Sedan Range

15-12

TECHNICAL BULLETIN

Locate Illumination – Flickering – Replace Dimmer Module Assembly

ILLUSTRATION 1

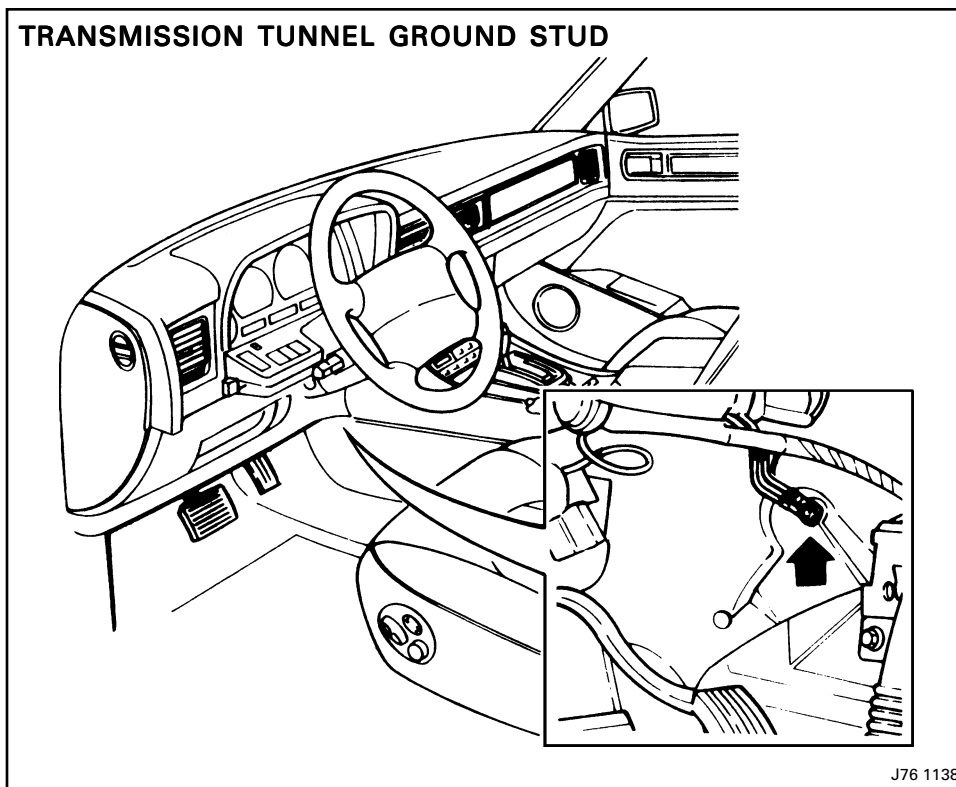
7. Locate the left hand console ground stud (FCG 26R) on the left side of the transmission tunnel, Illustration 1.
8. Disassemble ground lead eyelets and ensure that the mating faces of the ground stud as well as the eyelets are clean.
9. Re-install the eyelets and nut on the stud. Torque the nut to 3.6 - 5.1 lb ft (5 - 7 Nm).
10. Use a digital display multimeter to check the continuity of the Dimmer Module power ground at the Dimmer Module vehicle harness multiplug between SC1 - Pin 4 (black) and the battery negative lead.
11. Install the new Dimmer Module assembly in the mounting bracket.
12. Connect the rheostat harness connector to the Dimmer Module.
13. Connect the vehicle harness to the Dimmer Module connector and slide it into the mounting bracket.
14. Install the lower column cowl.
15. Reconnect the vehicle battery.
16. Reset the clock.
